# KETCHIKAN, ALASKA SHIPYARD PARKING LOT & LAYDOWN AREA

69115

As Built Plans  
 Project Engineer: Mark Figley  
 Start: September 21, 2006  
 End: April 10, 2007

**TYPICAL SECTIONS**

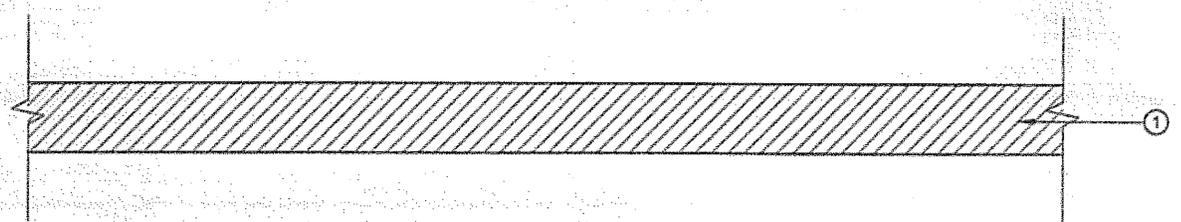
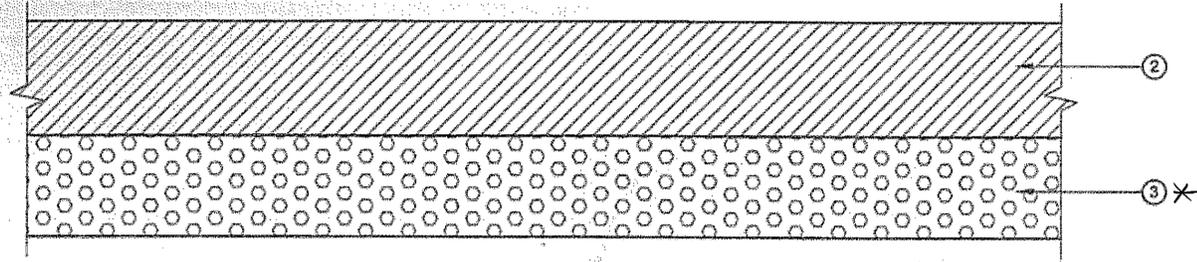
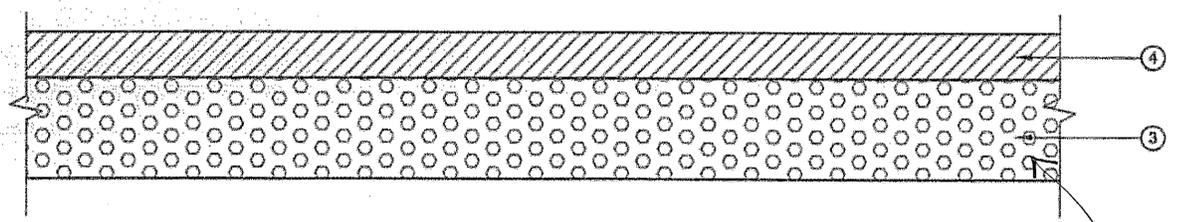
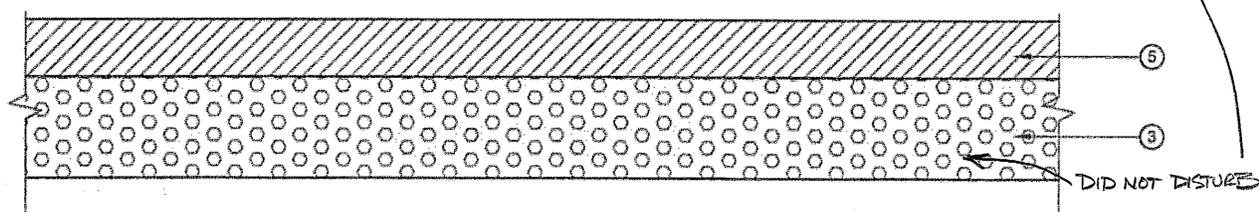
- ① 6" AGGREGATE BASE COURSE, GRADING D-1
- ② 8" AGGREGATE BASE COURSE, GRADING D-1
- ③ BORROW TYPE A 10" MIN. \*
- ④ 3" AGGREGATE BASE COURSE, GRADING D-1
- ⑤ 3" AGGREGATE BASE COURSE, GRADING D-1

STATE OF ALASKA  
DEPARTMENT OF TRANSPORTATION  
& PUBLIC FACILITIES  
STATEWIDE DESIGN & ENGINEERING  
SERVICES DIVISION  
SHIPYARD PARKING LOT  
& LAYDOWN AREA  
PROJECT # 69115  
**TEMPORARY  
OFFICE AREA  
GRADING TABLE**

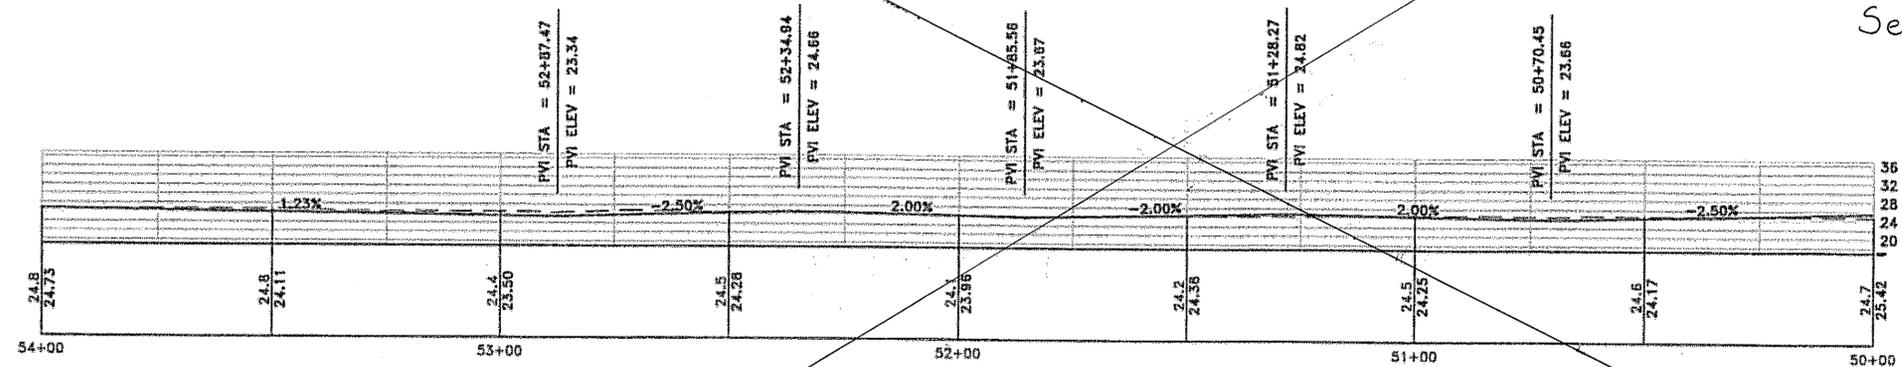
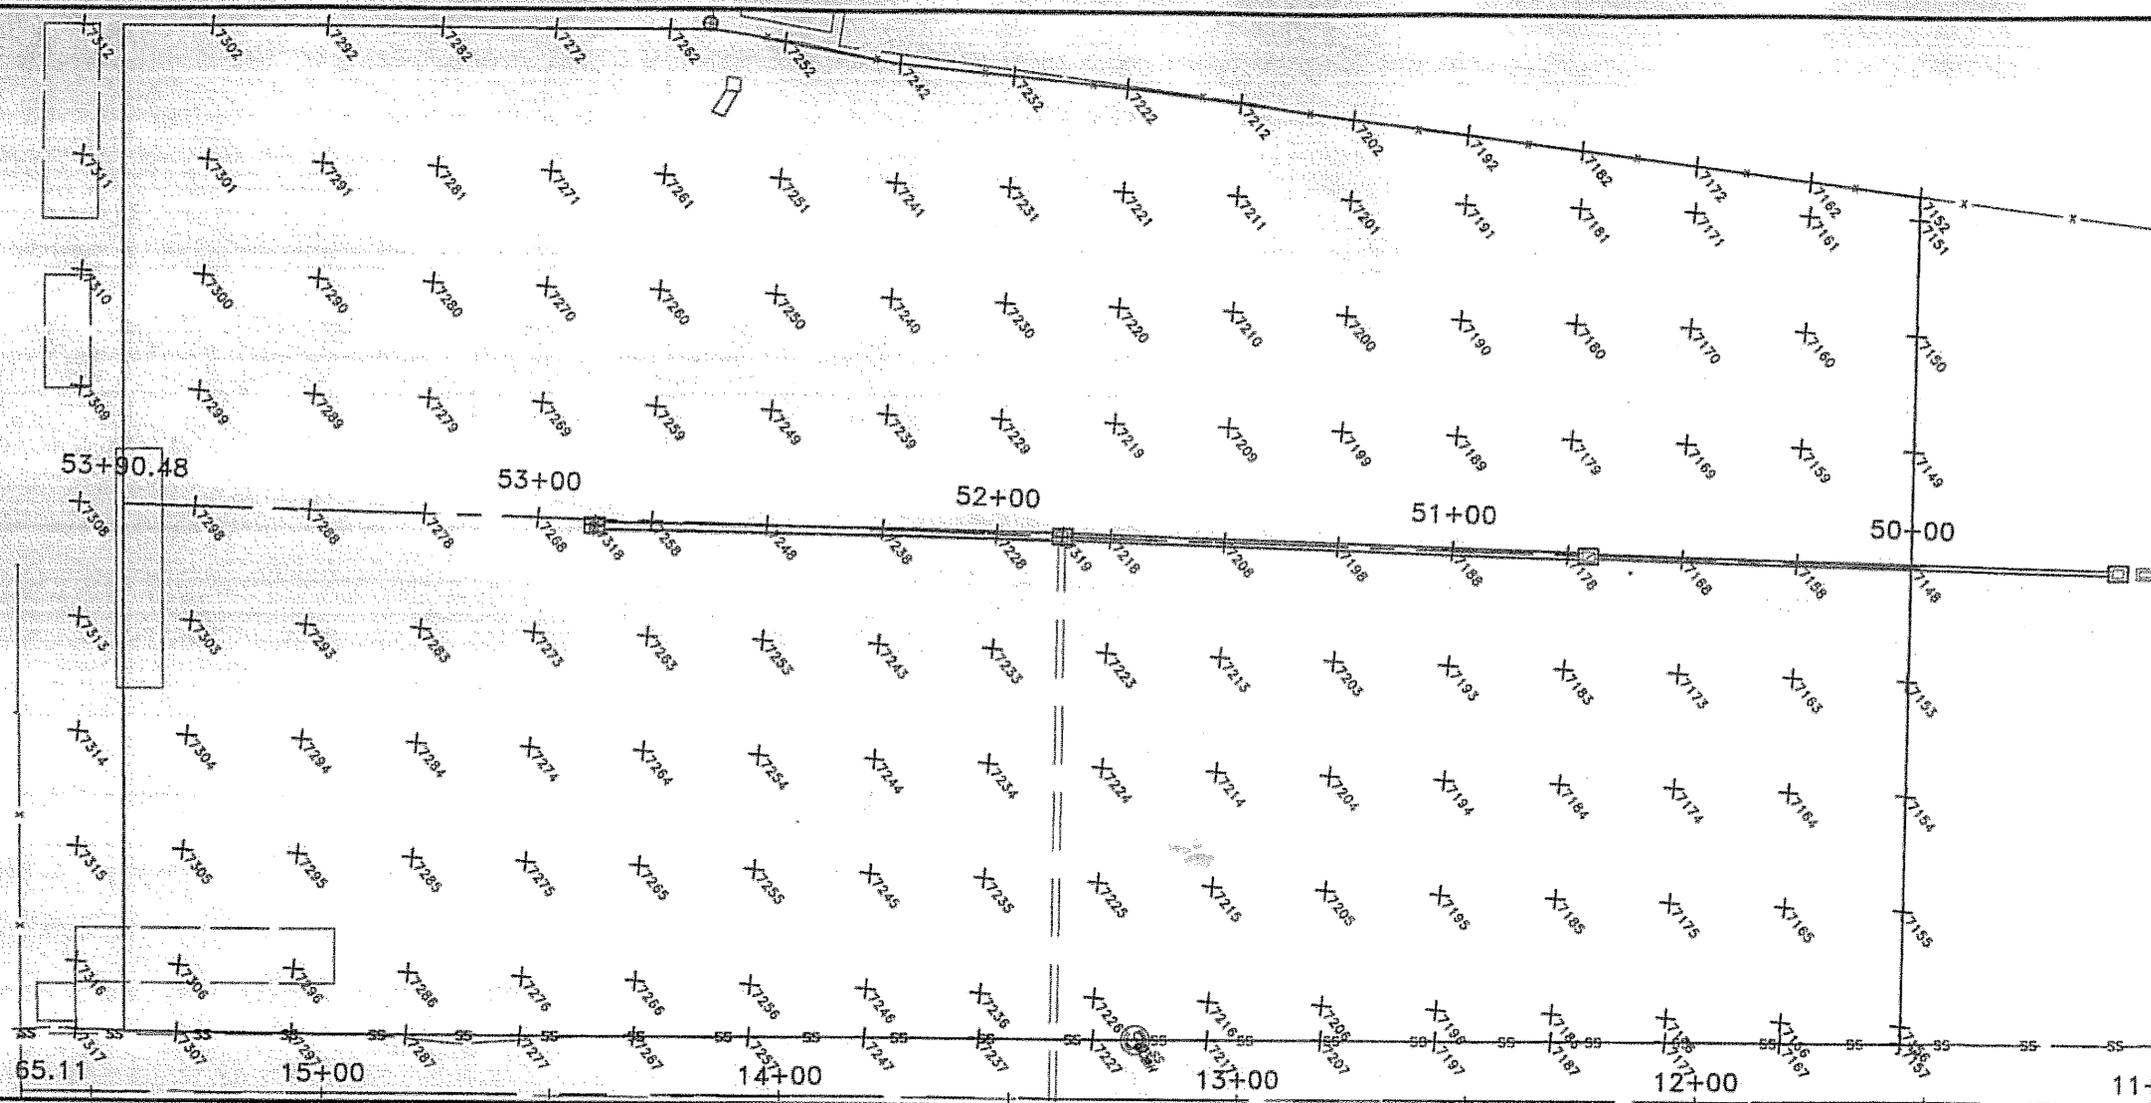
See Grade sheet pg. G6

STATE OF ALASKA  
 DEPARTMENT OF TRANSPORTATION  
 & PUBLIC FACILITIES  
 STATEWIDE DESIGN & ENGINEERING  
 SERVICES DIVISION  
 SHIPYARD PARKING LOT  
 & LAYDOWN AREA  
 PROJECT # 69115  
**FUTURE CONCRETE  
 PAD AREA  
 GRADING PLAN**

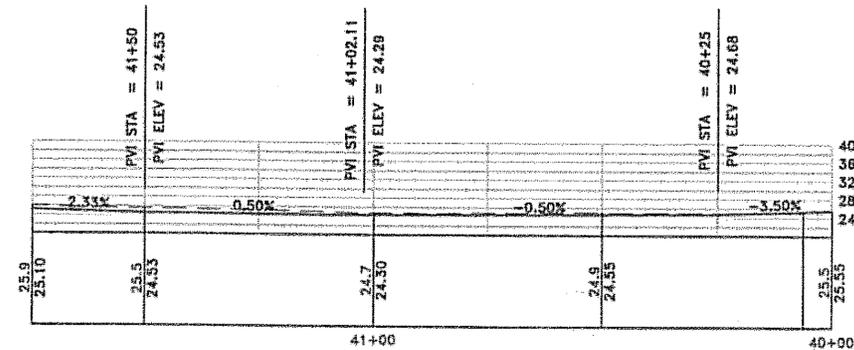
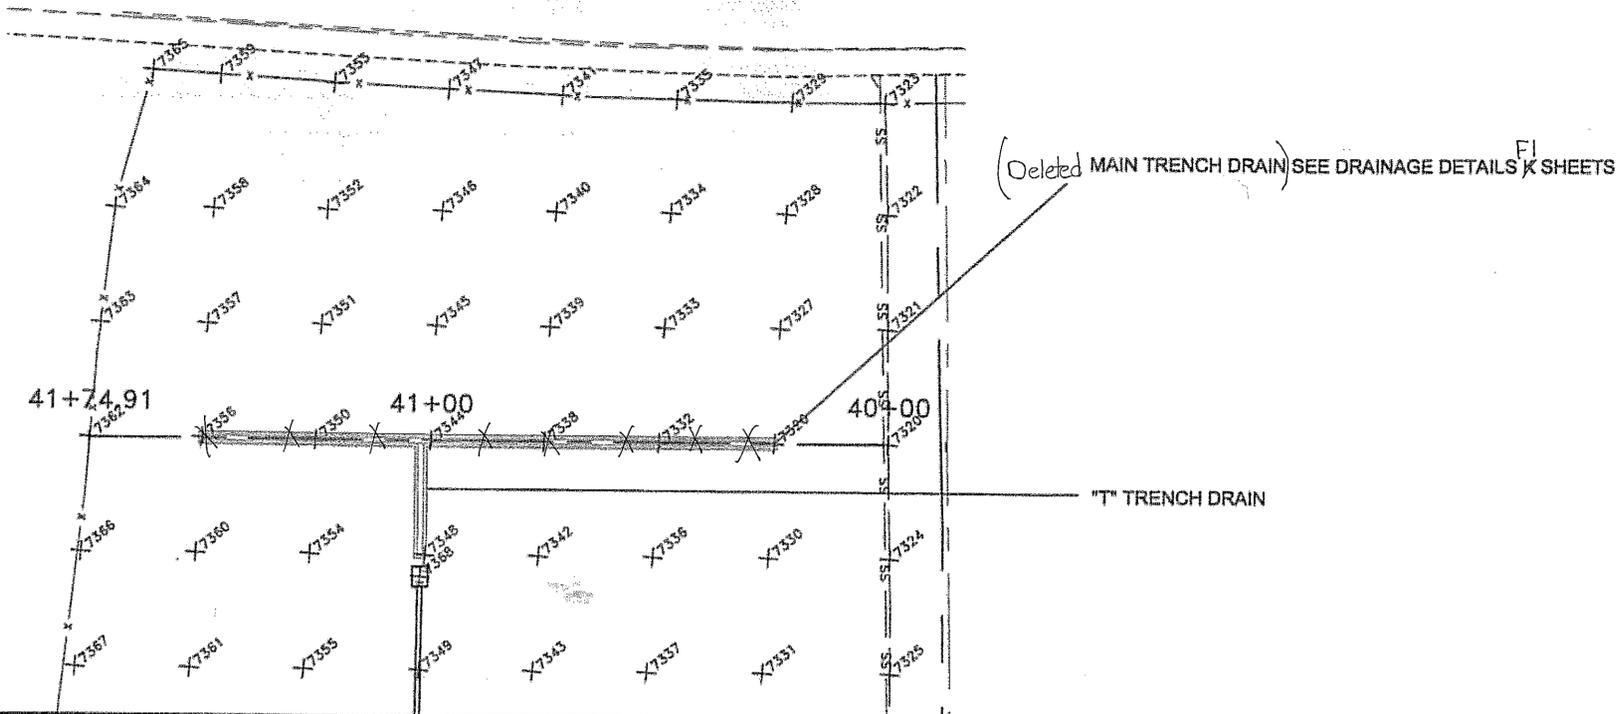
Note: typical change on Base Course  
New Typical is 3" of Base Course

SHEET NUMBER	TOTAL SHEETS
J4	25

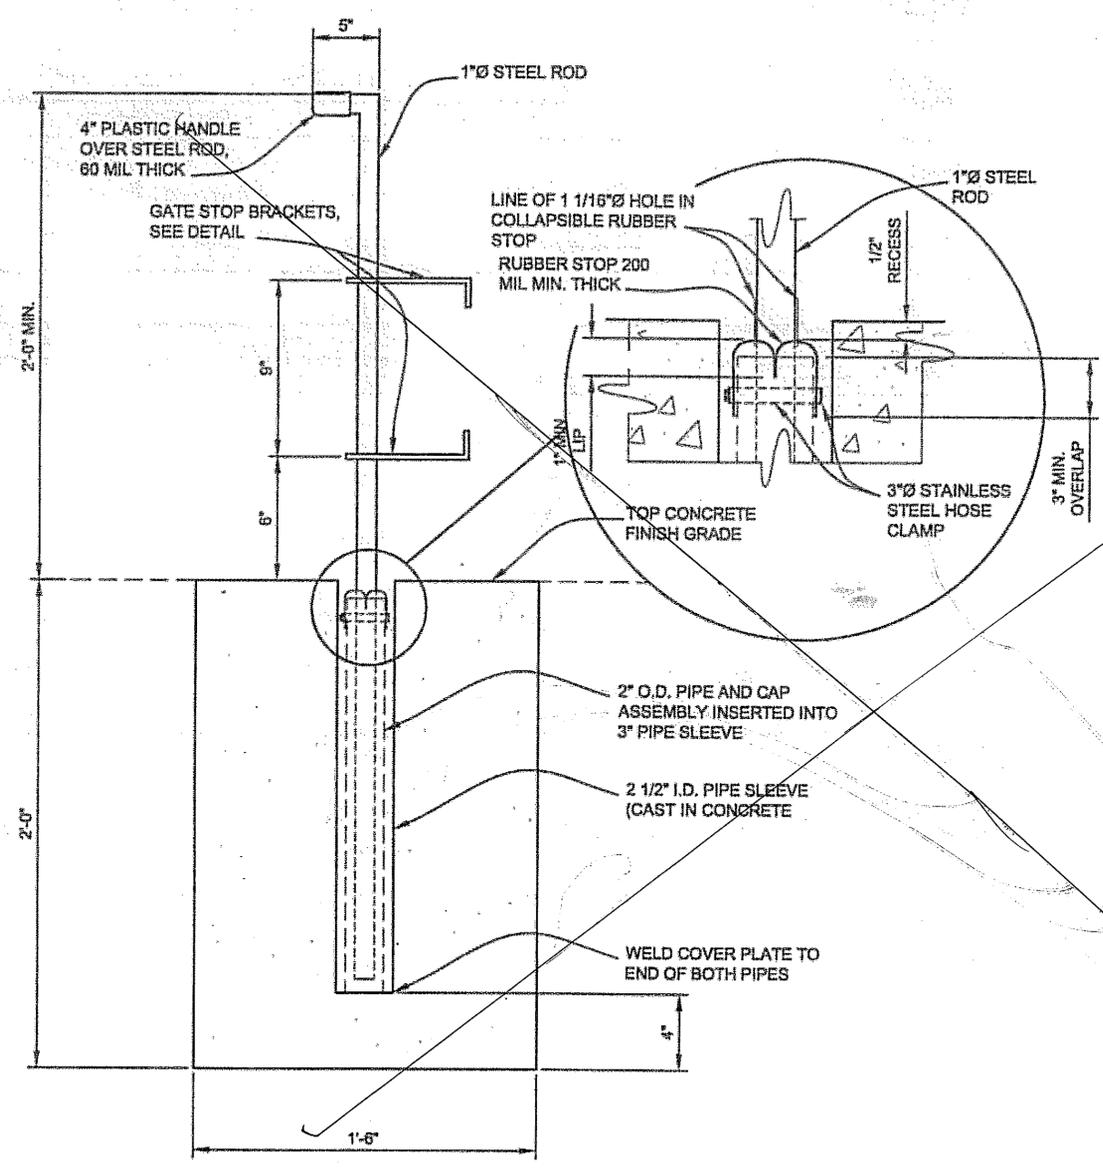
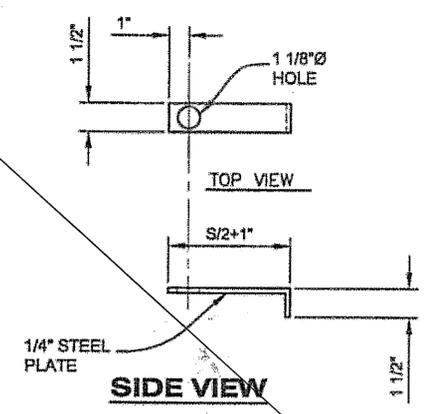
Not used

STATE	YEAR
ALASKA	2006
SHEET NUMBER	TOTAL SHEETS
K2	25

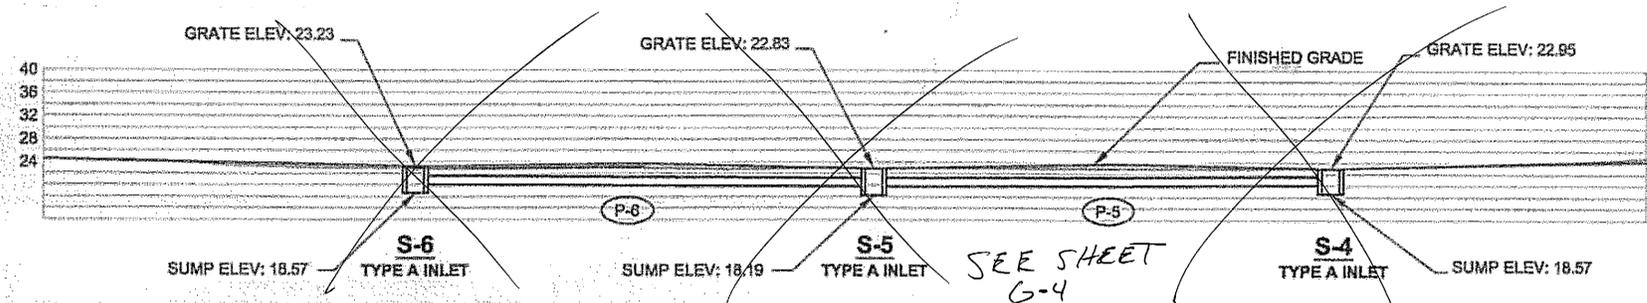
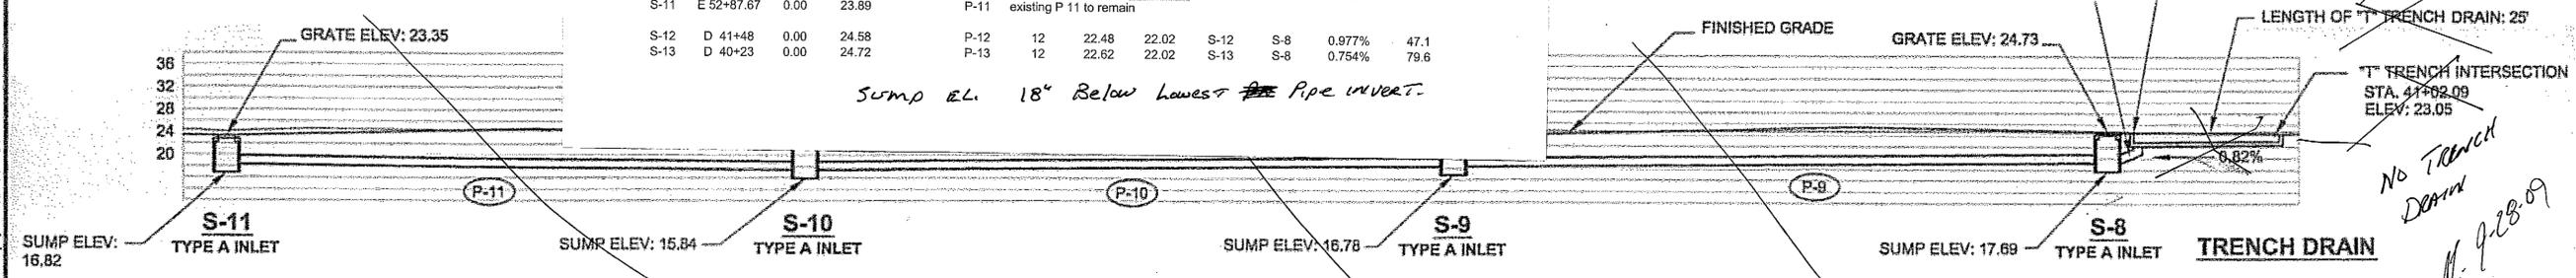
structure	station	offset	grate el	pipe	Dia in	inlet invert	outlet invert	from	to	slope	length
S-8	D 41+02	10' Lt	24.62	P-8	18	22.02	21.47	S-8	S-9	0.408%	135.44
S-9	E 50+70.45	0.00	23.87	P-9	18	21.47	21.00	P-9 and P-8 are now one pipe called out as P-8 above.			
S-10	E 51+85.56	0.00	23.80	P-10	18	21.47	21.00	S-9	S-10	0.408%	115.11
S-11	E 52+87.67	0.00	23.89	P-11	18	21.47	21.00	existing P 11 to remain			
S-12	D 41+48	0.00	24.58	P-12	12	22.48	22.02	S-12	S-8	0.977%	47.1
S-13	D 40+23	0.00	24.72	P-13	12	22.62	22.02	S-13	S-8	0.754%	79.6
